STAFF REPORT

DRCC #:25-1724D

PROJECT NAME: New Jersey Public Health, Environmental, and Agriculture
Laboratory (NJ PHEAL) Expansion

PROJECT NAME: NJ PHEAL Expansion

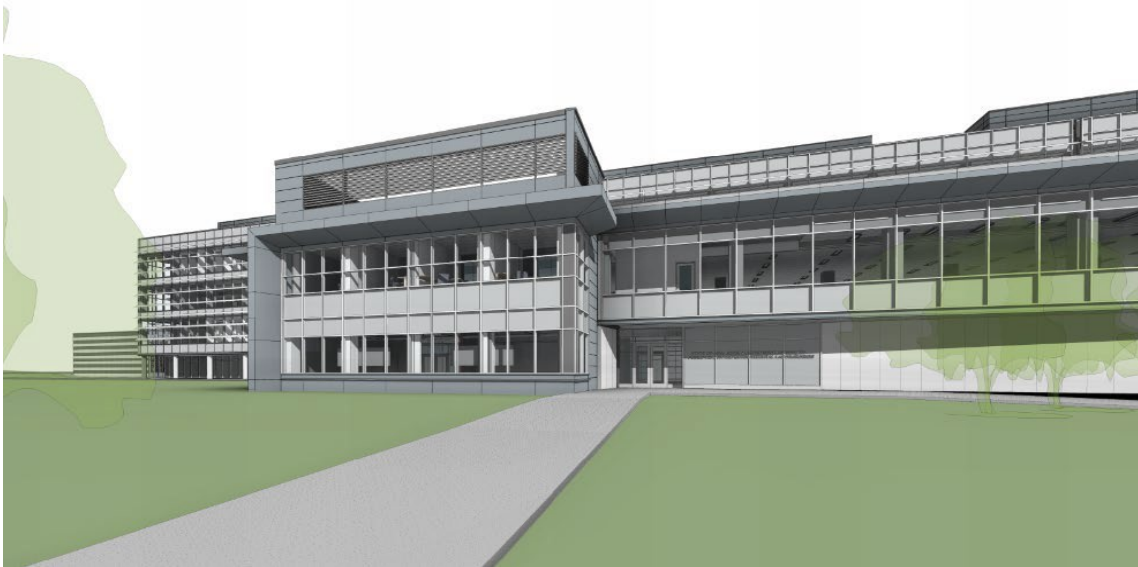
N.J.A.C. 7:45-10.4(b) directs that projects in Review Zone A shall maintain a reasonable height and scale relationship to nearby structures or vegetation. In the Rural canal environment, structures shall be limited to a height of 40 feet above existing grade where existing vegetation does not provide adequate winter screening. The applicant has submitted architectural elevations which indicate that the proposed building additions would range from 28 feet, 0.5 inches in height for the warehouse addition, 32 feet for the administrative addition, and 92 feet, 9 inches in the case of the laboratory addition, which corresponds to the height of the existing building.

While the height of the laboratory addition is greater than the 40-foot limit, Commission staff observes that the height would not be greater than the existing NJ PHEAL building approved by the Commission in 2009. Commission staff, therefore, recommends that the

project be granted a waiver of strict adherence from the visual, historic, and natural quality impact review standards based upon the criteria set forth at N.J.A.C. 7:45-12.7(a)1, and 2.ii., which states that a project may be waived from strict adherence to the standards if the applicant establishes to the satisfaction of the Commission that visual screening will continue to exist in the future, and the topography of the land screens the entire project from the view of a person in the Delaware and Raritan Canal State Park.
